**Re: DA22/0122 – Electricity Generating Works – Solar Farm
1268 Oxley Bridge Road, Uranquinty**

Habitat continue to act on behalf of Bison Energy and provide this response to the following correspondence received in relation to Development Application 22/0122:

Figure 1 – Extract Wagga Wagga LSPS – Uranquinty Structure Plan

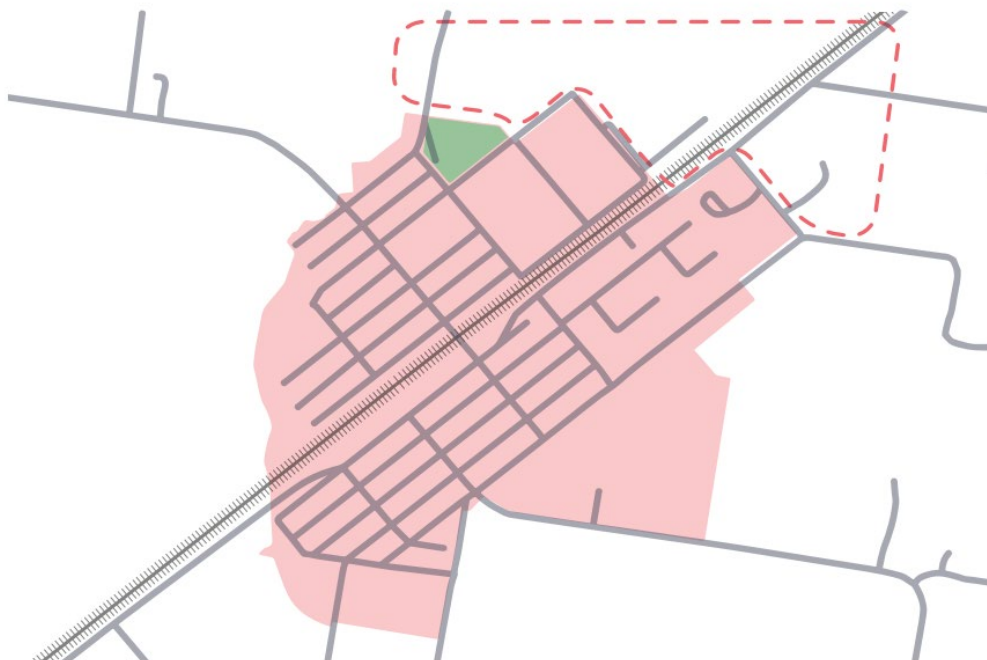
Submissions raised concern that the proposed solar farm would limit residential growth of Uranquinty and would have 'impacts' on the established urban residential areas. The solar farm is located approximately 1km from the nearest vacant urban zoned land and approximately 1.6km from the nearest populated urban areas. At this distance and perceived impact would be considered low. The solar farm proposes significant landscaping and is also supported by a visual impact assessment and glint and glare assessment that demonstrates that impacts on the village of Uranquinty are negligible.

Furthermore, the proposed solar farm is not considered to have any potential impact on the growth of the urban area of Uranquinty. A review of the *Wagga Wagga Local Strategic Planning Statement* and *Wagga Wagga Spatial Plan 2013-2043* notes that the only identified urban growth for Uranquinty is to the north of the established township. A review of the current land zoning map also clearly demonstrates that there is a considerable level of vacant zoned land around the township already. Therefore, any further growth of Uranquinty is unlikely during the life of the proposed solar farm.
